Job Title
RVR Level Crossing
Highway Works

Rother Valley Railway Level Crossing – B2244 Junction Road Stage 1 Road Safety Audit

**Rother Valley Railway Level
Crossing - B2244 Junction Road,
Udiam**

Stage 1 Road Safety Audit

Figure 1 Location of Recommendations

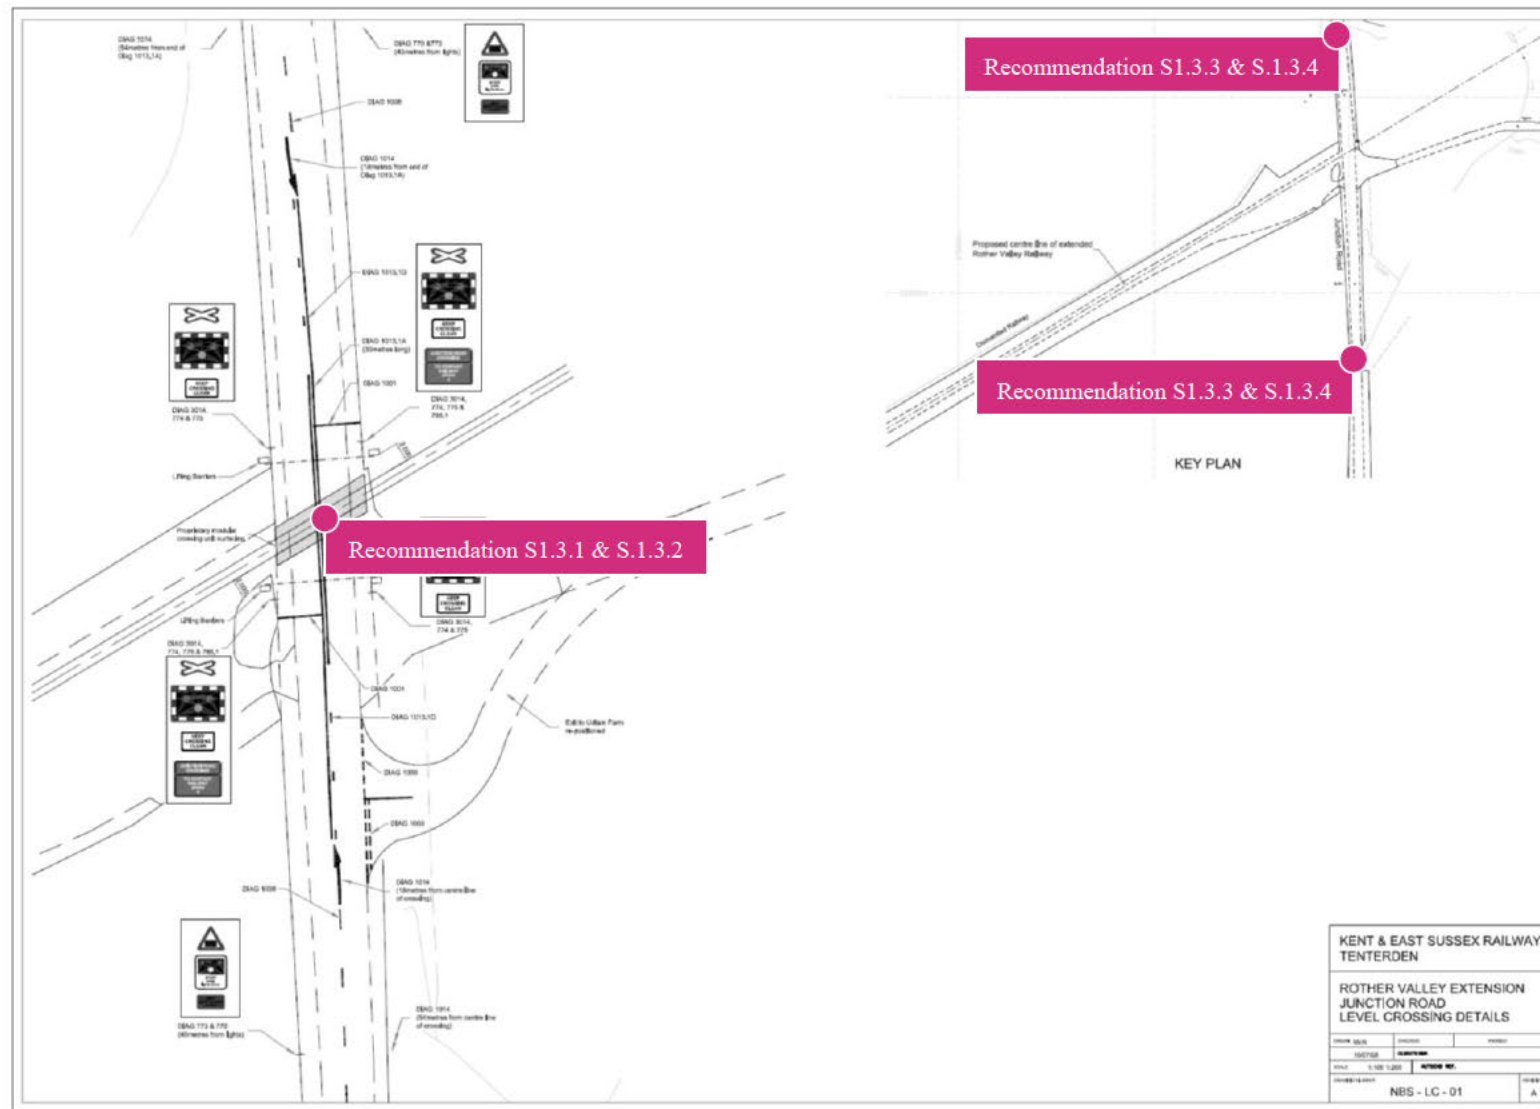
| Location: | B2244 Junction Road |
| Summary: | Speeding vehicles pose a threat to other road users. |
| Description: | <p>During the site visit, high vehicle speeds were observed along with a high frequency of heavy braking on the approaches to the narrow bridges.</p> <p>High risk behaviour such as high vehicle speeds and late, heavy braking will result in a higher frequency of collisions due to driver error.</p> |

| Summary: | Adjacent features increase the risk of blocking back at the level crossing. |
| Description: | There is a private access located close to the proposed level crossing location, in addition to the narrow bridges to the north and south. |

Turning traffic waiting on the carriageway by the level crossing will increase the risk of blocking back over the crossing leading to potential vehicle / train conflict.

Summary: Multiple traffic signs leading to distraction, missed warnings and road user collisions.

Description: There are a number of existing traffic signs on both the northbound and southbound B2244 in the vicinity of the proposed level crossing, notably those warning drivers of the narrow bridges.

The proposed level crossing layout does not consider the existing traffic signing, or the effect of the proposed level crossing signing on the existing signing. This could lead to drivers missing some signs and the warnings they portray leading to a range of conflicts and/or collision types.

Summary: Pinch points could lead to blocking back at the level crossing.

Description: There are two narrow bridges situated either side of the proposed level crossing site.

The bridges are too narrow for large vehicles to pass without forcing oncoming traffic to stop. A platoon of half a dozen vehicles could obstruct the crossing leading to potential vehicle / train conflict.

| S1.3.1 Recommendation: | Reduce the speed limit over this length of the road. |

S1.3.2 Recommendation: Introduce a yellow box marking to TSRGD Diagram 1045 to deter blocking back at the crossing.

S1.3.3 Recommendation: A comprehensive review of the existing signing on the B2244 should be incorporated into the detailed design of the level crossing including visibility splays to the various signs to demonstrate there will be no masking.

S1.3.4 Recommendation: Establish priority at the narrowings for vehicles driving away from the level crossing.
